August 7, 2023
AVO 37449

Re: Dollar General Final Plat and Construction Plans
First Review

The City of Sanger requested Halff Associates, Inc. review the Dollar General Final Plat and Construction Plans prepared by Triangle Engineering LLC. dated June 21, 2023. We have completed our review and have the following comments:

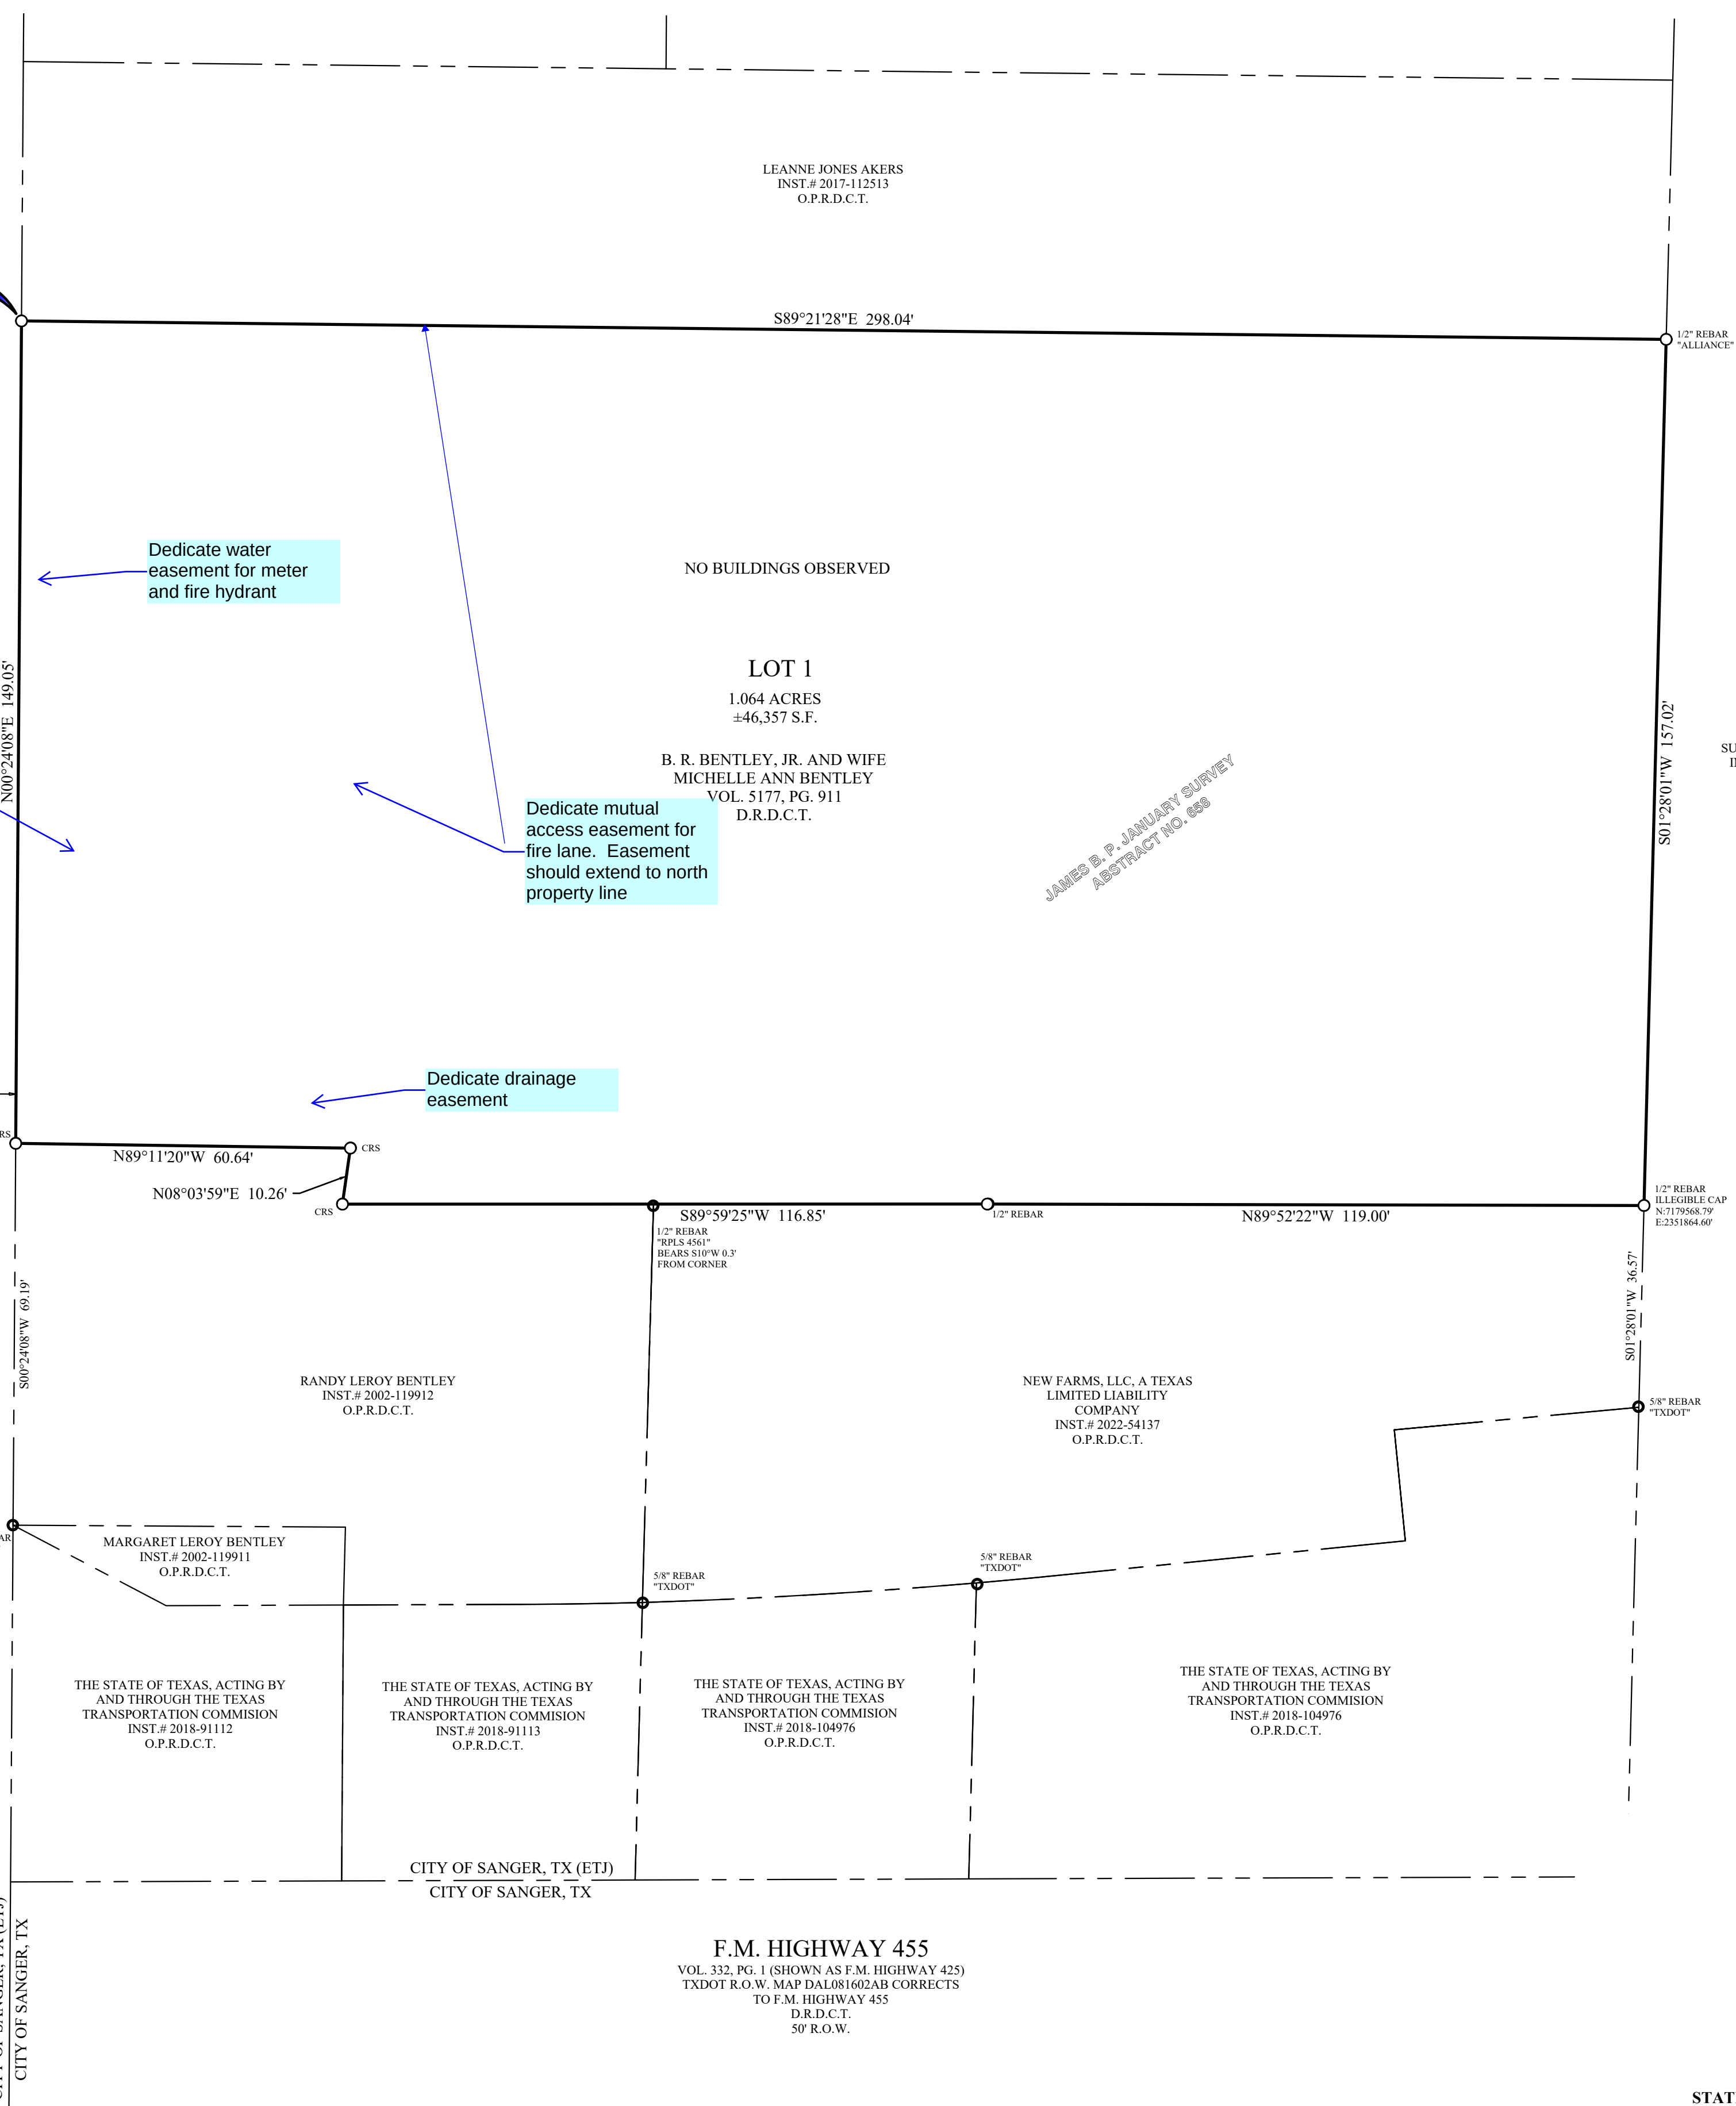
1. Dedicate the necessary drainage, water, and access easements. The drainage easement should encompass the proposed storm drain and overflow paths between the west and east property lines. The water easement should be provided for the proposed water meters and fire hydrant. The access easement should include the proposed fire lane and extend to the north property line.
2. Denton County Master Throughfare Plan indicates FM 2450 classified as a Major Arterial with 140' right of way at the intersection. This requires 45' of right of way to be dedicated.

Denton County MTP indicates FM 2450 is to be a Major Arterial with 140' ROW at the intersection. Dedicate 45' additional ROW

COVER SHEET

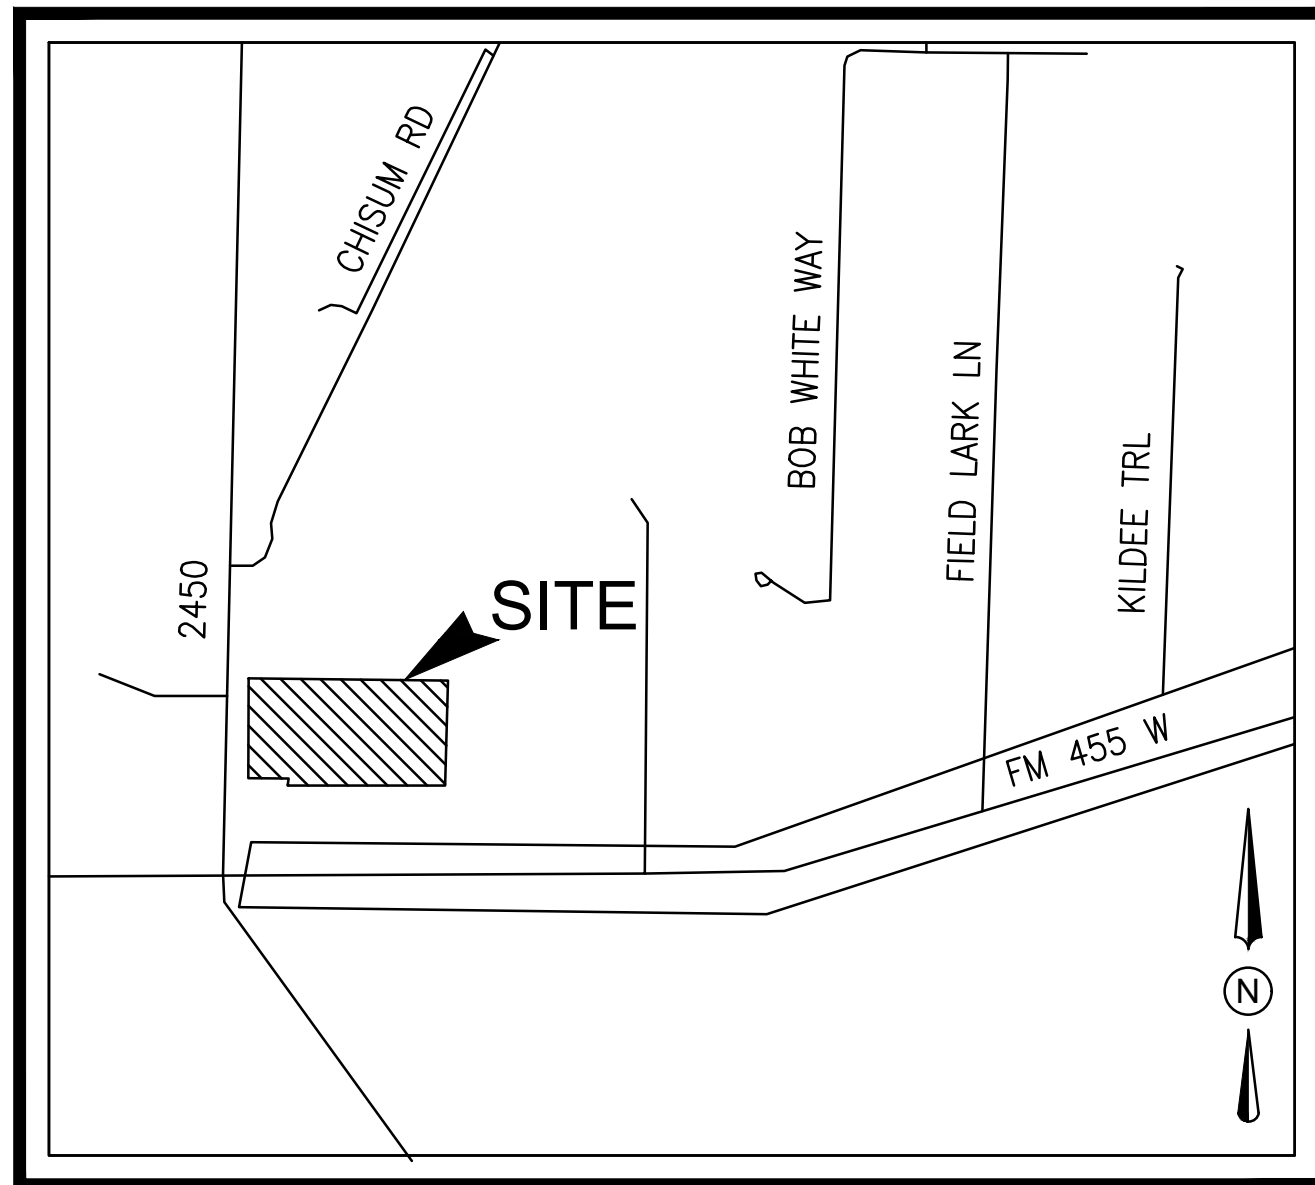
3. Include signature block for City.

Provide Plat

Provide City signature block

SITE PLAN
DOLLAR GENERAL
NE QUADRANT OF FM 2450 & CHAPMAN ROAD
CITY OF SANGER ETJ
DENTON COUNTY, TEXAS 76266
JAMES B.P. JANUARY SURVEY ABSTRACT NO # 658

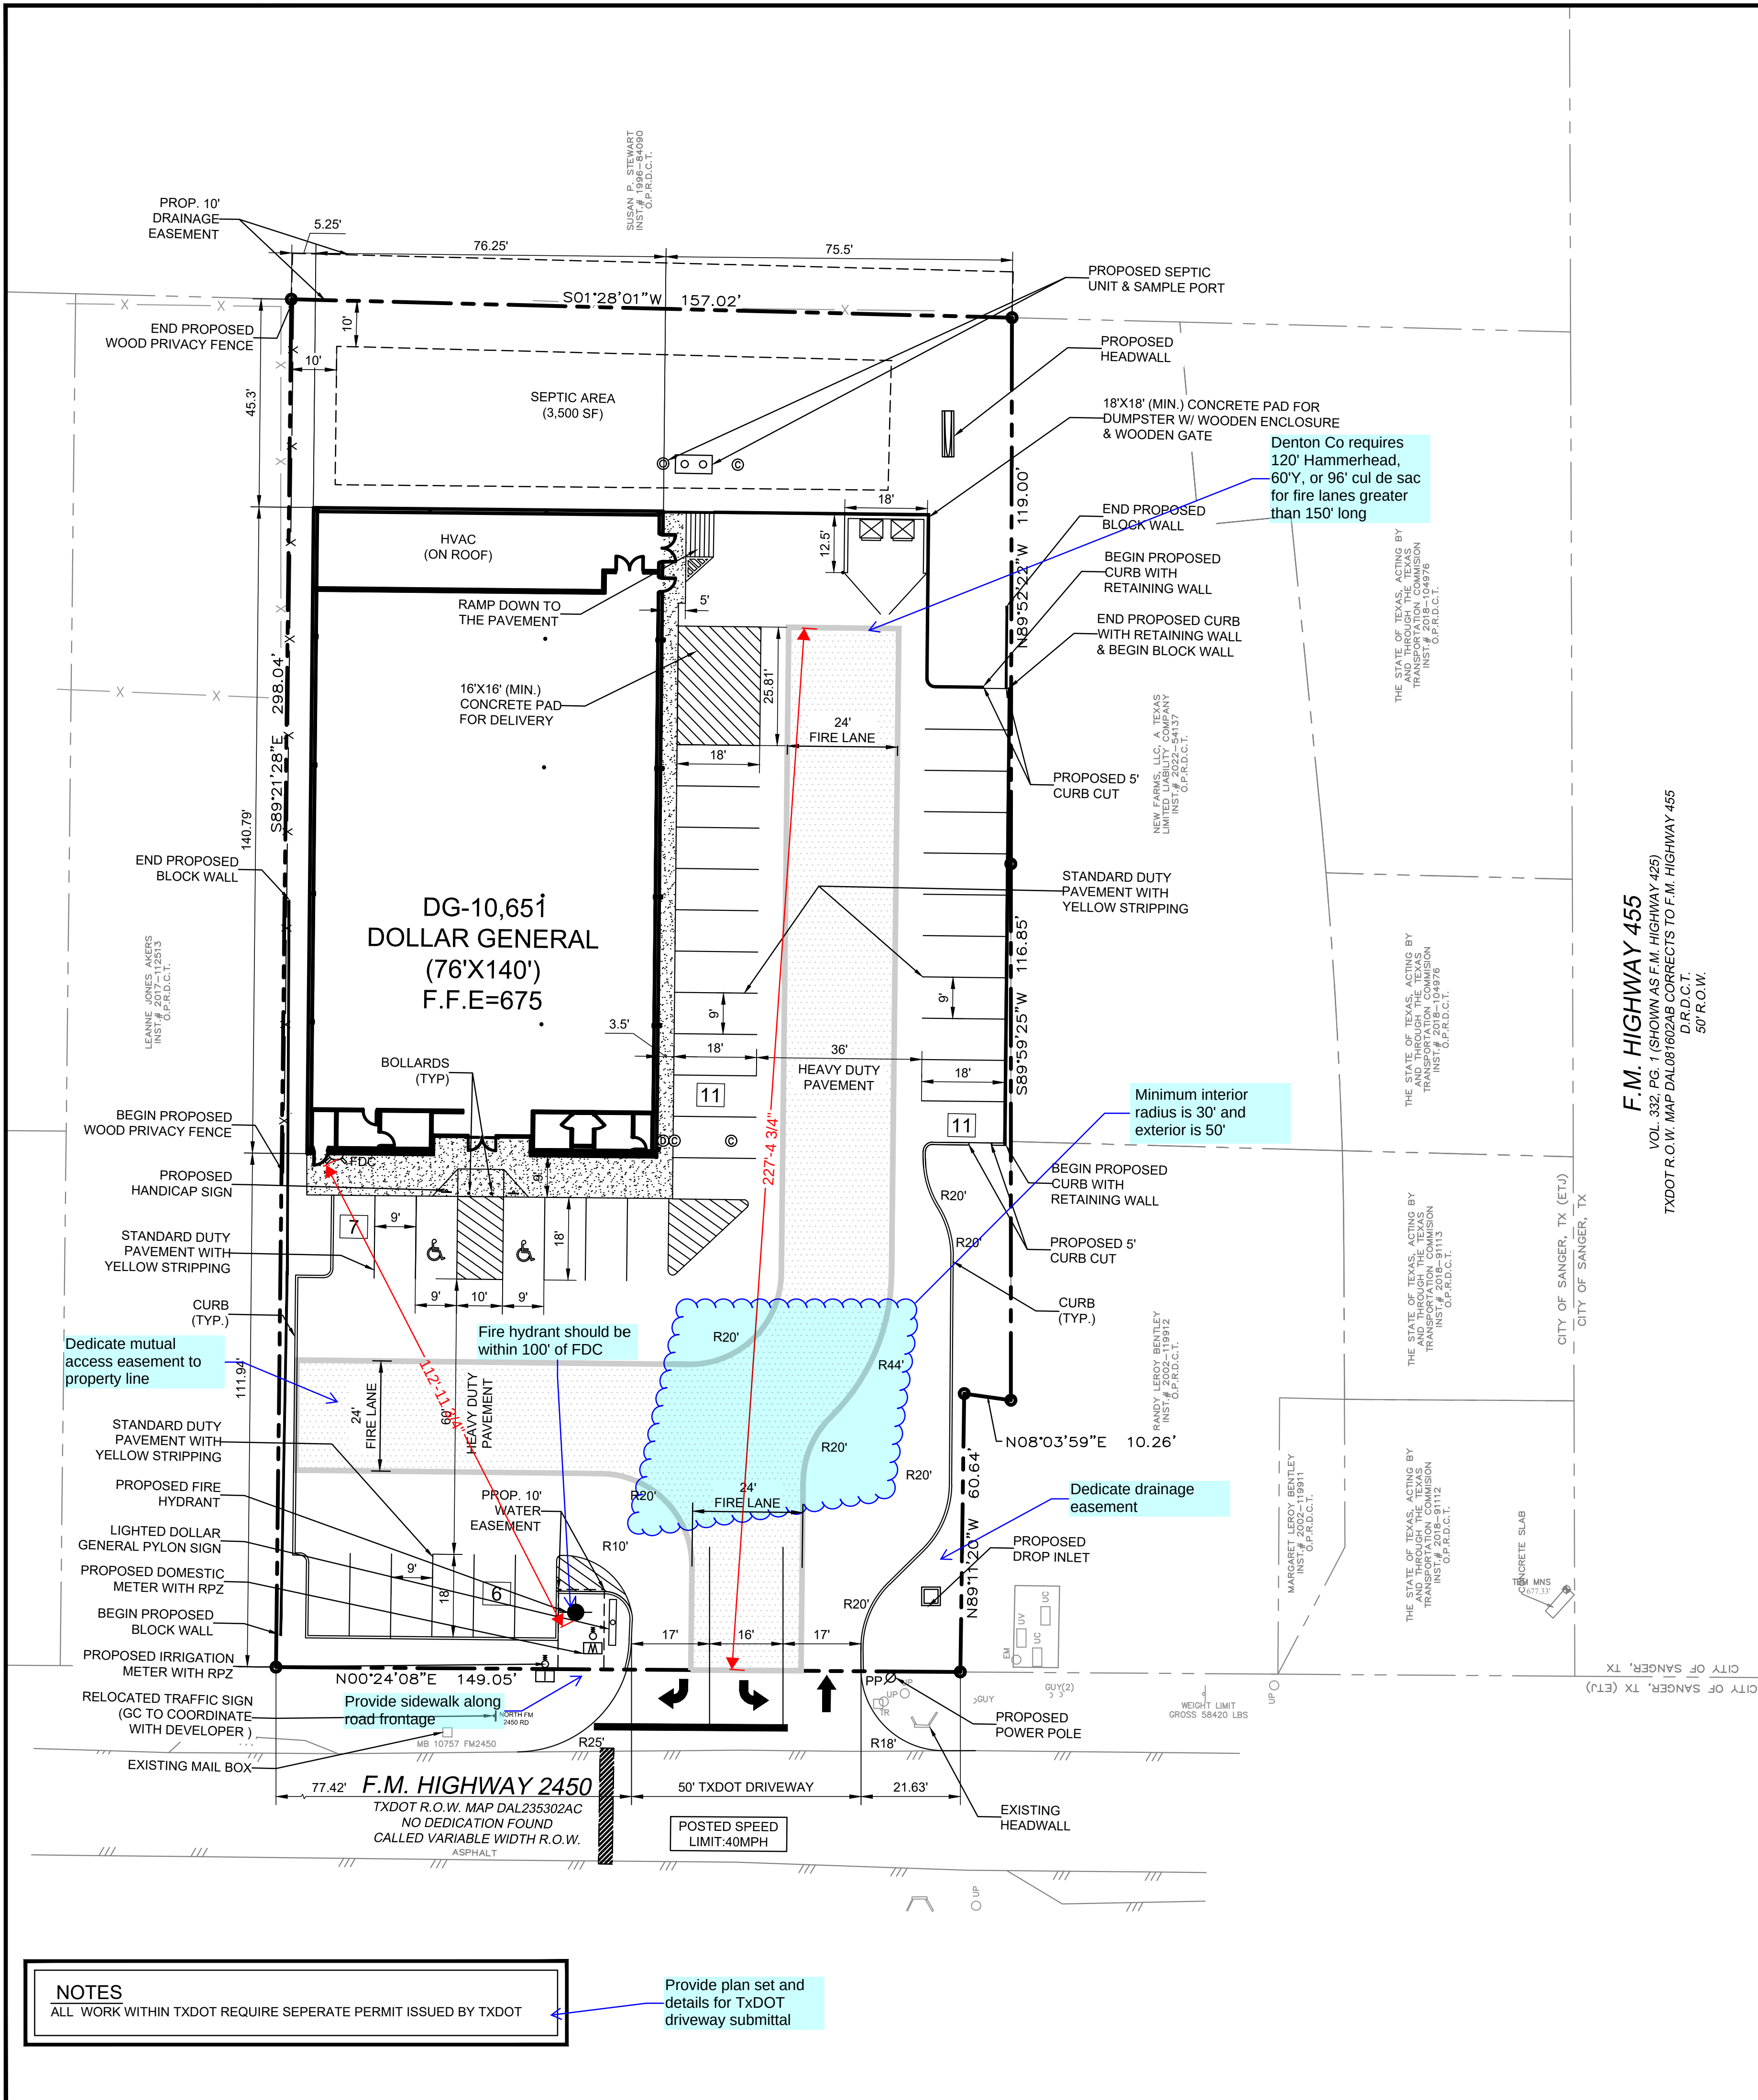
4. Show proposed easements on site plan.
5. Provide sidewalk FM 2450 frontage.
6. Locate fire hydrant within 100 feet of building fire department connection.
7. Denton County requires a fire department turn around for fire lanes over 150 feet long. The turnaround may be a 120' hammerhead, 60' Y, or 96' diameter cul de sac.
8. Denton County requires a minimum 30' internal and 50' external radius on all fire lanes.
9. Provide plans for TxDOT driveway and utility permit application.
